NOTICE OF VIOLATION

On September 11, 2024, Energy Safety conducted an inspection of PG&E's WMP initiatives in the vicinity of the City of Los Gatos, California. The inspection report is enclosed herewith. Energy Safety found the following violation(s):

INSPECTION REPORT

Structure ID: 146103

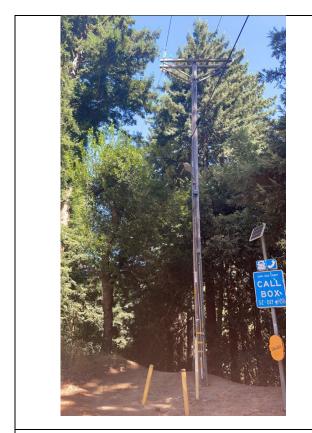
On Pole ID 146103, Grid Hardening ID 31658944, at 24152-24212 Santa Cruz Hwy, Los Gatos, CA, 95033, USA, 37.11868920121737, -121.97500711929922, the inspector observed that one of the CalFIRE-exempt fuses was not attached to the cutout. The inspector's observation is documented in Violation 1 photographs, which are attachments to this report. Photo numbers Item1GImg1, Item1IA1Img1, Item1IA1Img2, and Item1IA1Img3 depict incomplete installation of CalFIRE-exempt fuses. Pacific Gas and Electric Company reported that work on WMP initiative 8.1.2.10.5 – Non-Exempt Expulsion Fuses was completed at this location.

1. One CalFIRE-exempt fuse was not attached to the cutout.

Item1IA1Img1: View of the empty fuse cutout.
